**AGENDA
TECHNICAL REVIEW COMMITTEE
REGULAR MEETING
AUGUST 13, 2020
9:00 AM
CITY HALL COMMISSION CHAMBERS
204 ASH STREET
FERNANDINA BEACH, FL 32034**

- 6. NEW BUSINESS**
- 7. OLD BUSINESS**
 - 7.1 SPR 2018-07 Mocama Brewery: Trey Dennard with Dreamscapes - Proposed Landscape Plan Revisions
 - 7.2 SPR 2019-11 Bistro 2020: Wayne Chism with Chism Development Company to discuss 2nd round of review comments.

2nd STREET ELEVATION

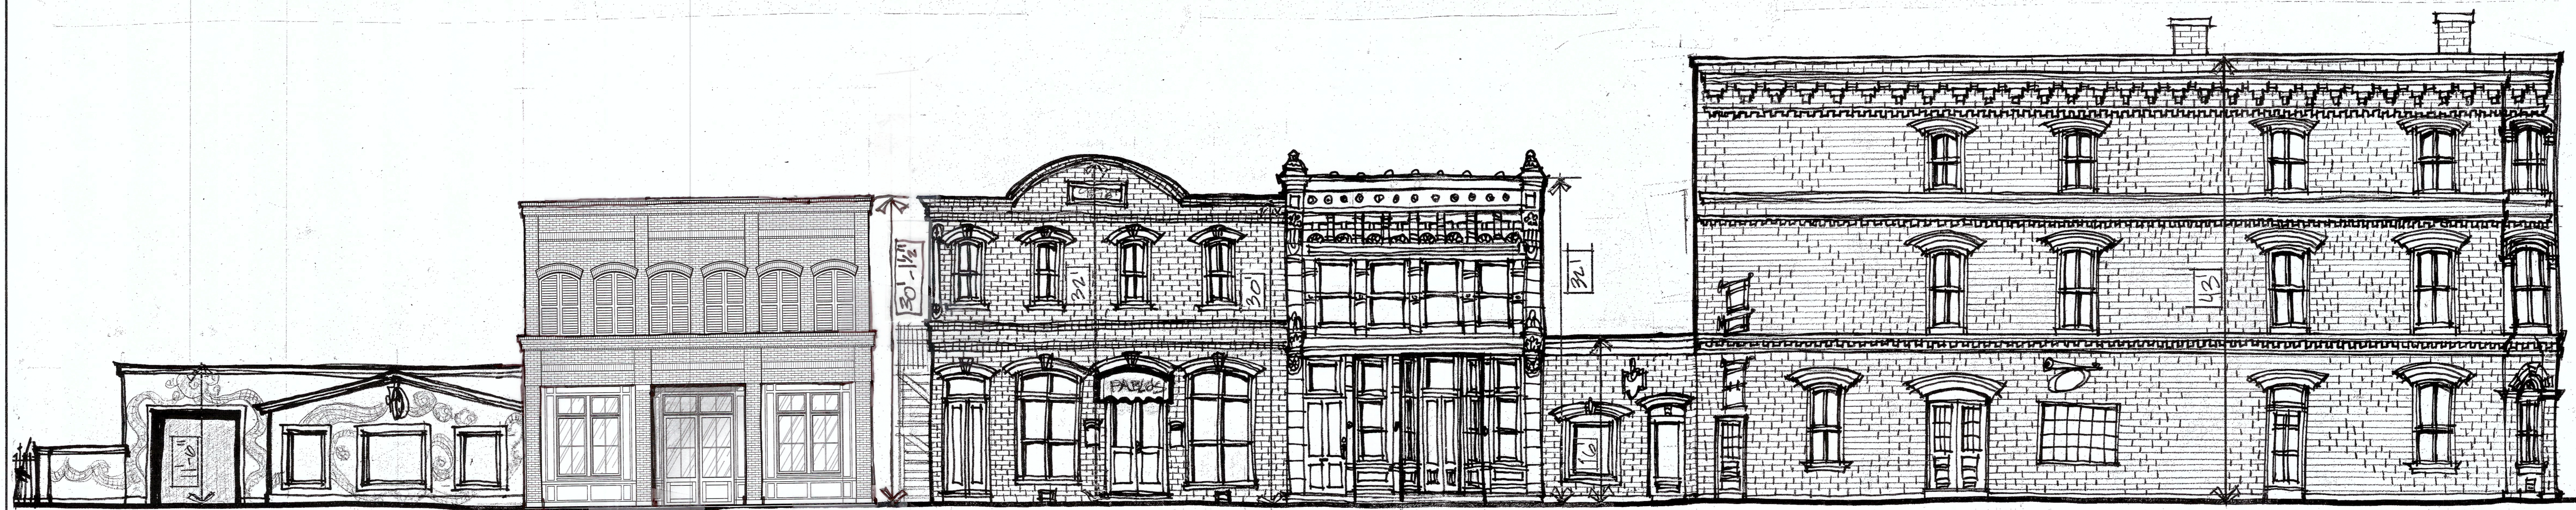
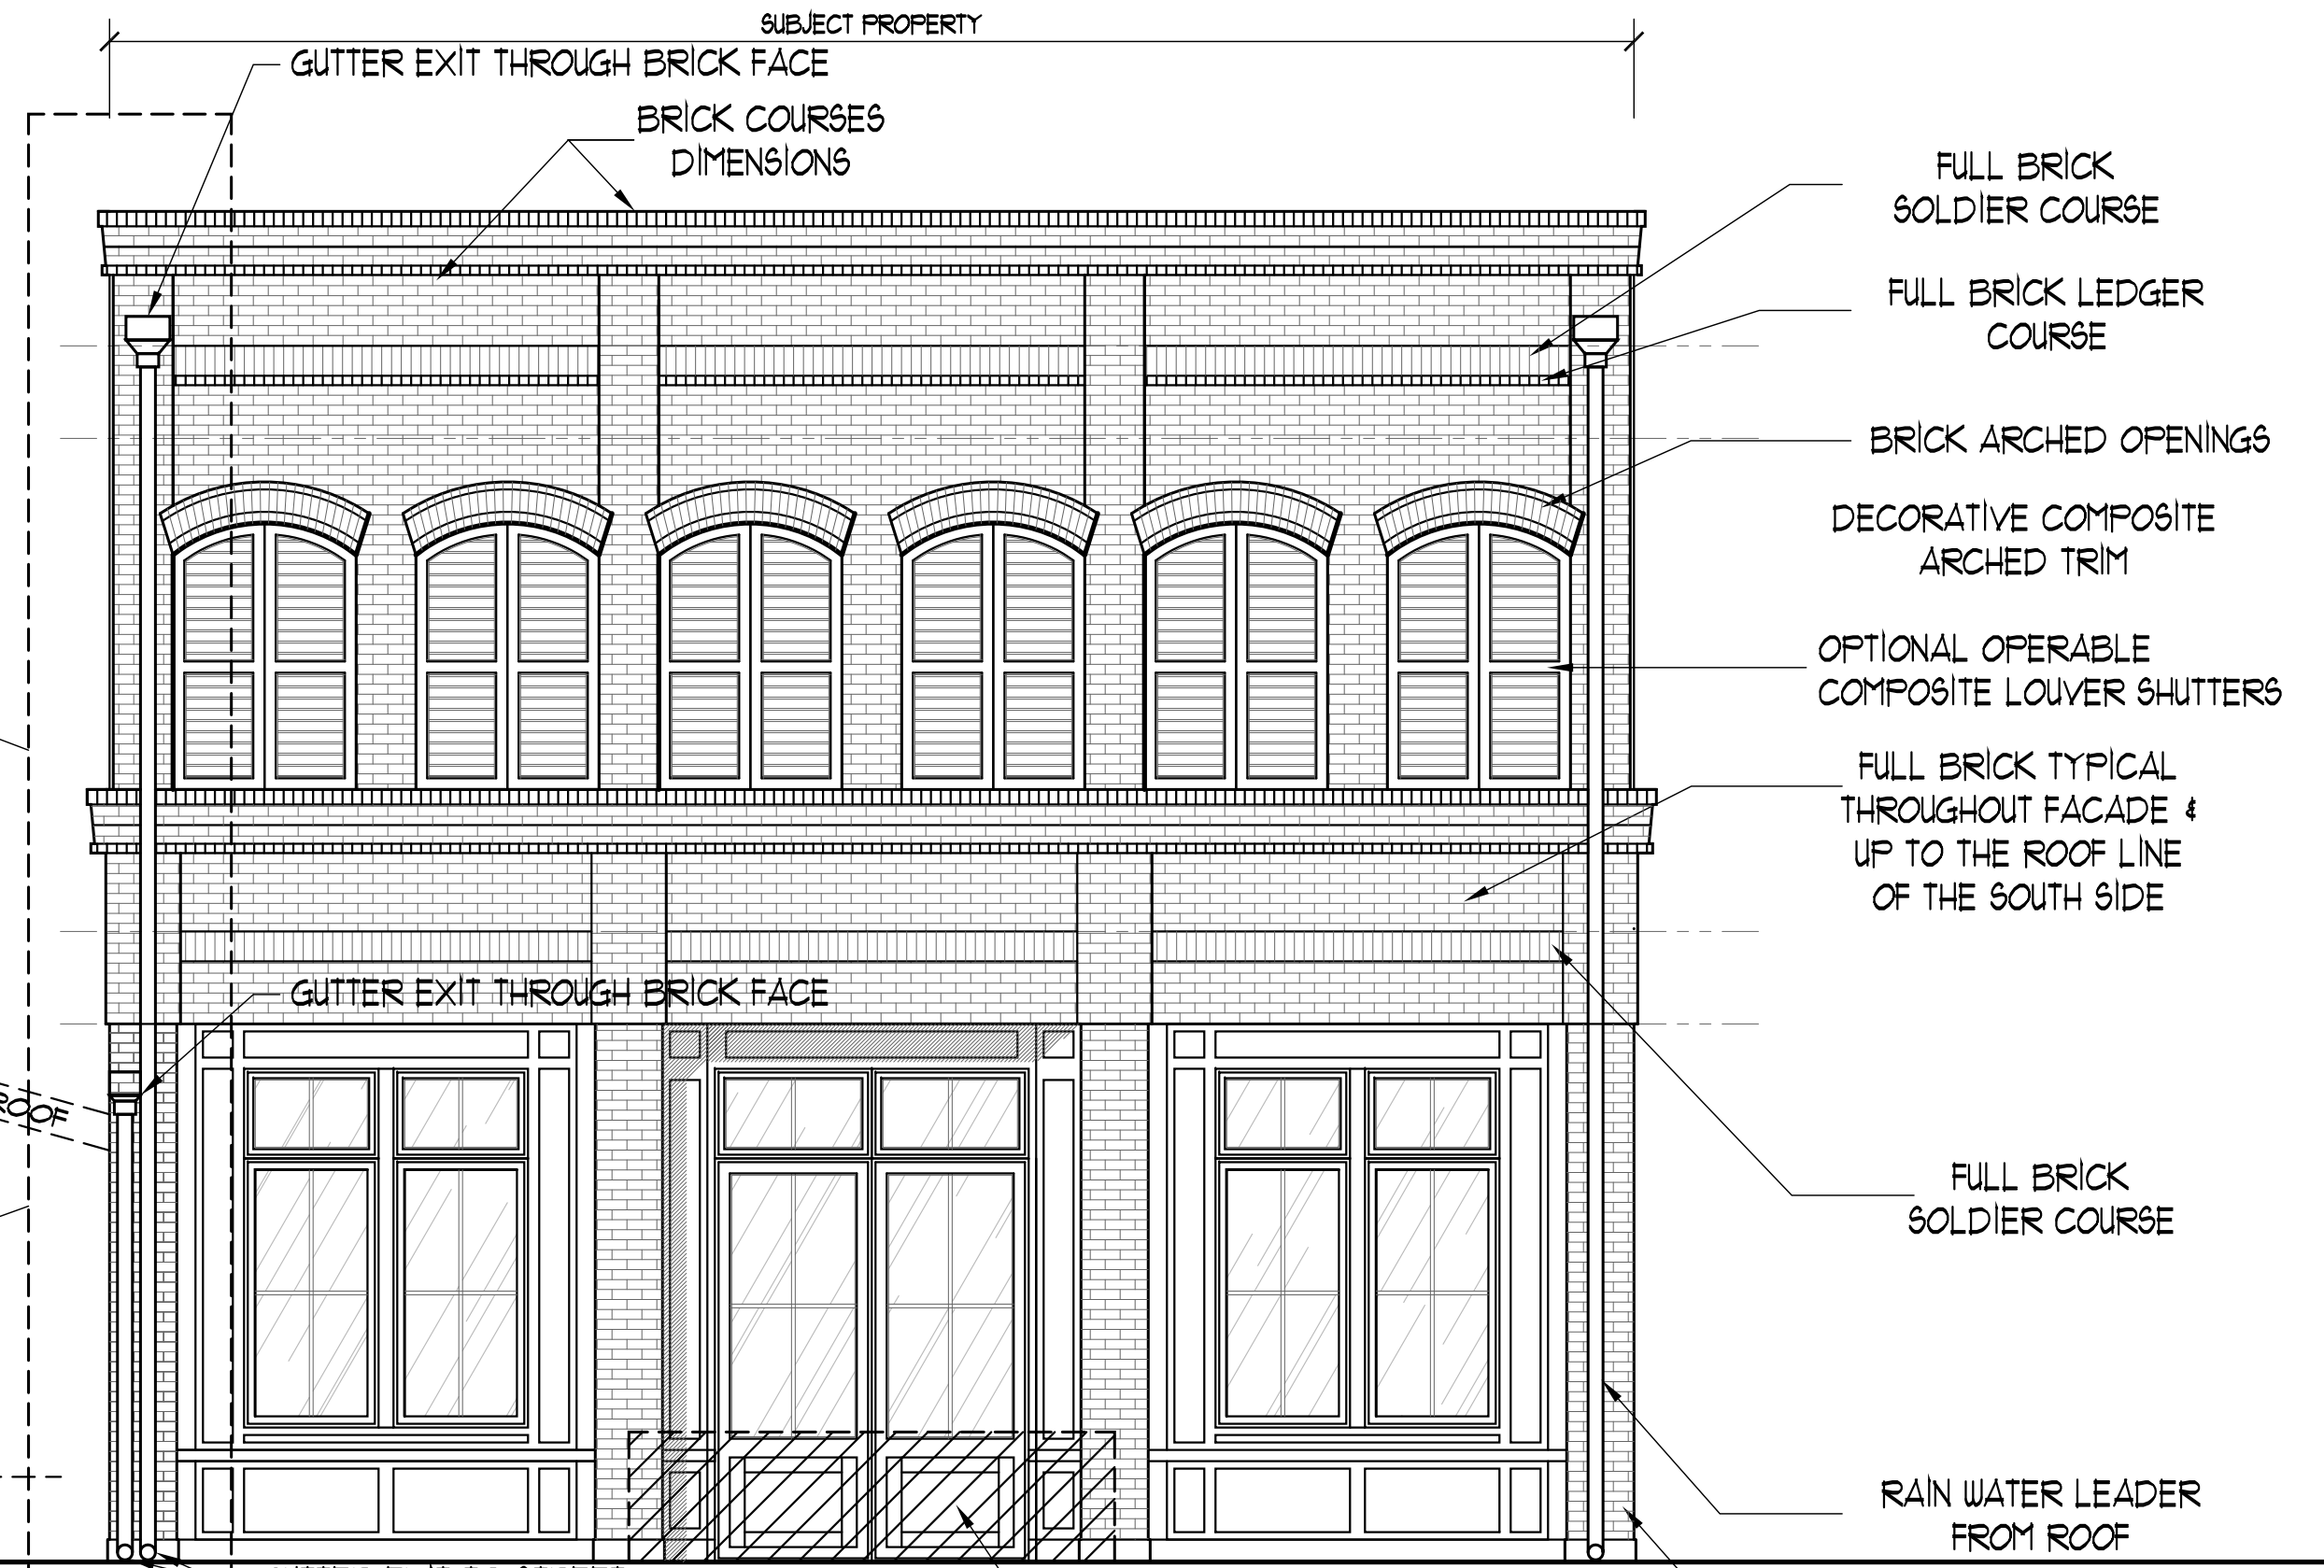
- Sheet S-2 has the Green Space Calculation and provides a breakdown of the square footage of the required green space.
 - The Rear Elevation shown on sheet A-2, shows the proposed 36" permanent roof access ladder.

- B. Minimum Tree Planting Nonresidential:
 - The 3 shade trees are existing and proposed to remain consisting of 2 palm trees and 1 holly.
- The 2nd Street Elevation on sheet A-2 shows where the proposed flood barrier will be erected. This will not affect the façade of the building.

ROOF PLAN/
DRAINAGE PLAN

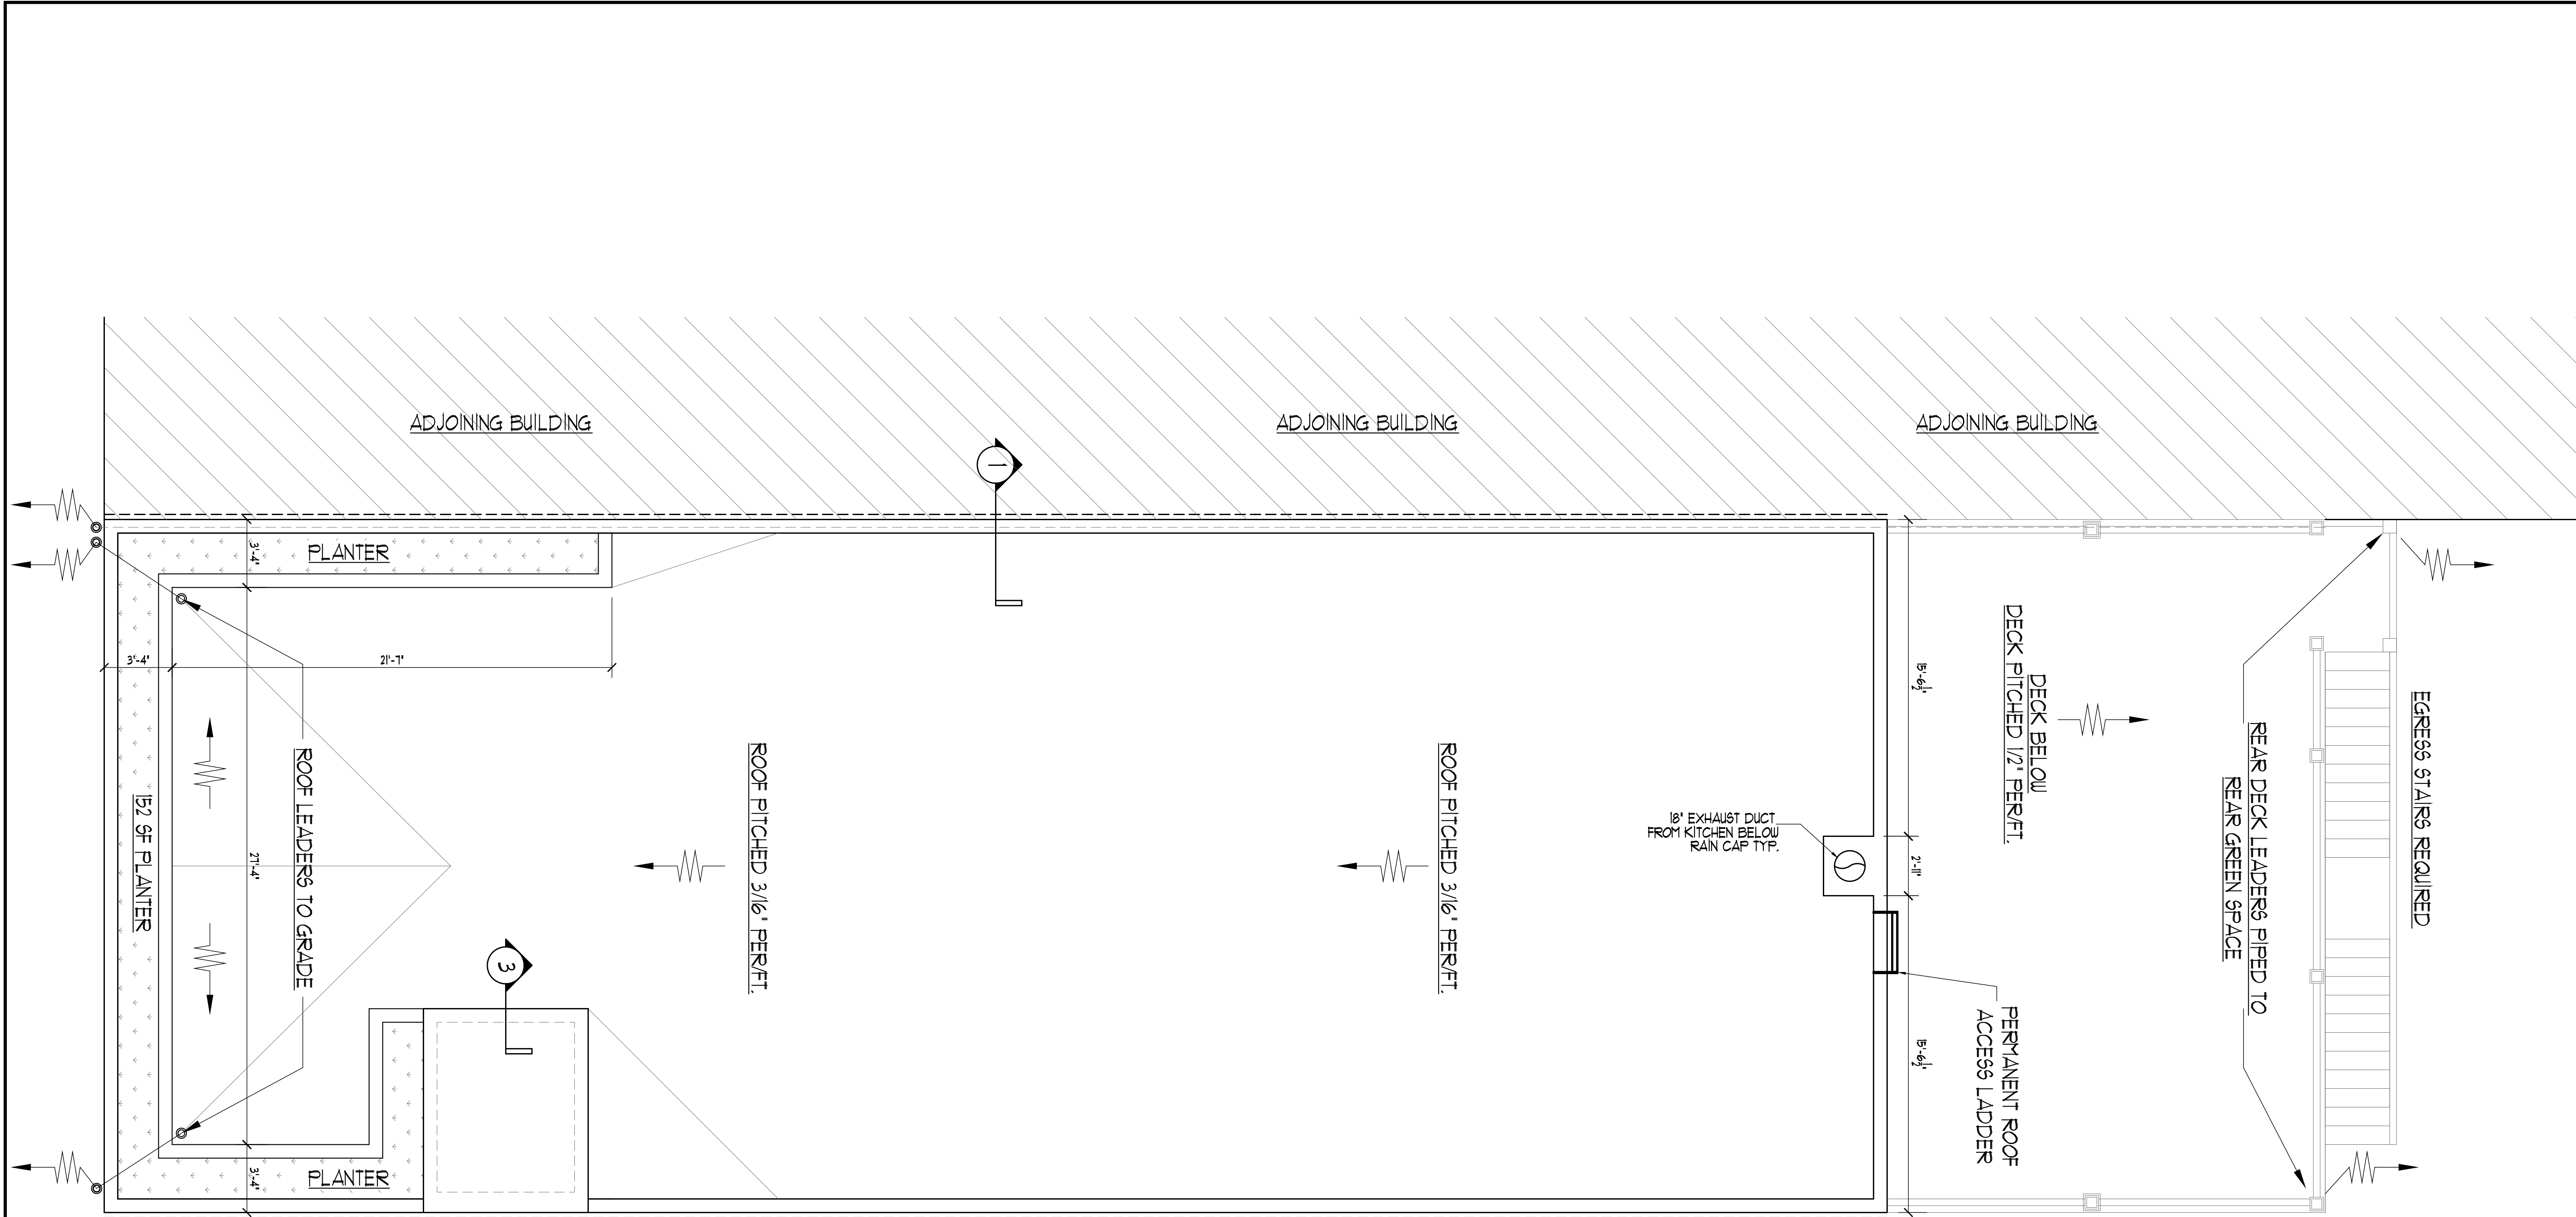
- The Drainage Plan is provided on sheet A-9; depicting a 3/16" per foot pitch to direct water flow. Also, the plans proposed rain gutters perforated pipe located in the wall with the drain through the brick face into a leader to the street, on the North and South sides of the property.

- As shown on sheet A-11, Suite 1 is accessed either through its own entrance through the 2nd floor reception area or the rear shared egress deck.
- Sheet A-9 shows the roof plan with the west facing deck on the 2nd floor has a roof above it with the roof leaders' locations depicted. The east facing deck on the 2nd floor is open.
- The location of the electrical meter and service disconnect is shown on sheet A-10.
